May 15, 2023

**RWB CONSULTING ENGINEERS  
MECHANICAL, PLUMBING & ELECTRICAL ADDENDUM 2 ITEMS FOR  
T.E. BAXTER ES - HVAC REPLACEMENT  
MIDLOTHIAN I.S.D.**

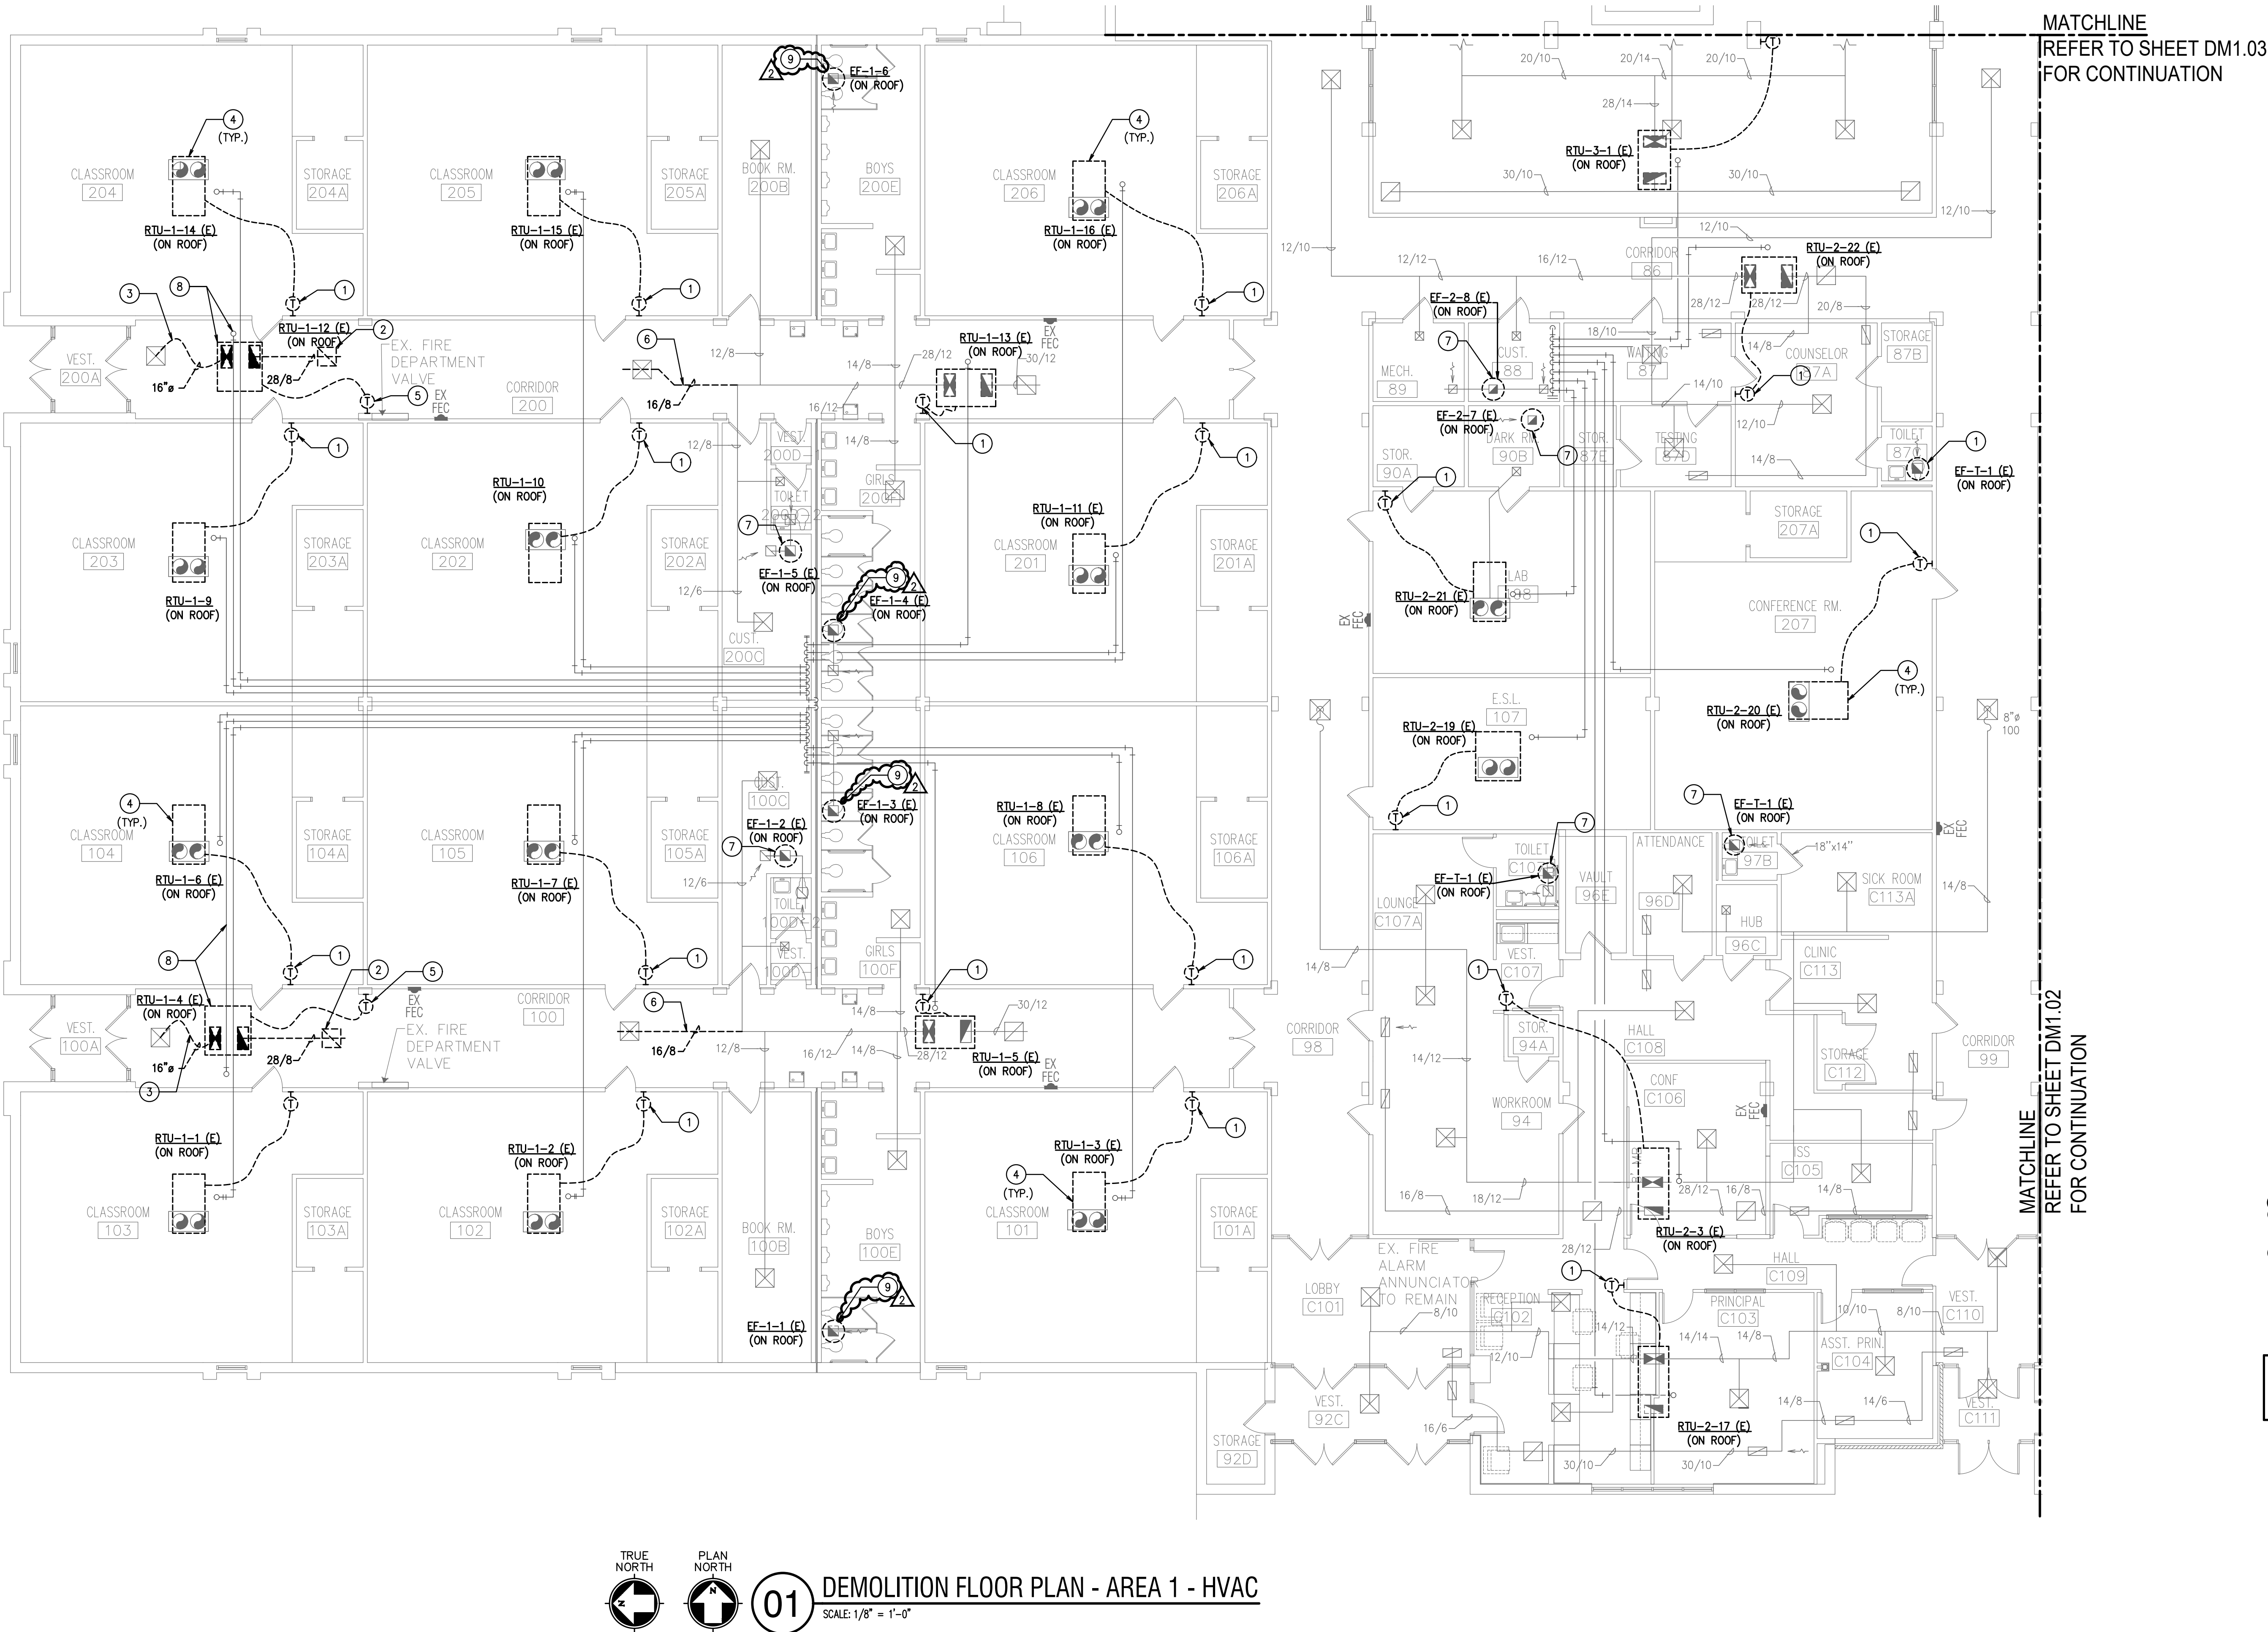
1. DMPE1.01 – DEMOLITION ROOF PLAN – MPE
  - A. Refer to Keynote 1 under Notes by Symbol and revise to read as follows:  
 “1. REMOVE EXISTING NATURAL GAS ASSEMBLY FEEDING EXISTING ROOFTOP UNIT AND CAP FOR FUTURE CONNECTION TO NEW ROOFTOP UNIT. EXISTING GAS COCK/PLUG VALVE TO BE REMOVED AND REPLACED WITH NEW.”

2. MPE1.01 - ROOF PLAN – MPE
  - A. Refer to Keynote 1 under Notes by Symbol and revise to read as follows:  
 “1. CONTRACTOR TO REPLACE EXISTING NATURAL GAS ASSEMBLY TO NEW ROOF TOP UNIT. REFER TO DETAIL '1' ON DRAWING MP2.01 FOR GAS CONNECTION TO ROOF TOP UNIT DETAIL. EXTEND PIPING AND ADD ROOF TOP SUPPORTS AS REQUIRED FOR FINAL CONNECTION TO UNIT. PROVIDE NEW GAS COCK/PLUG VALVE AT EACH UNIT IN PLACE OF EXISTING.”
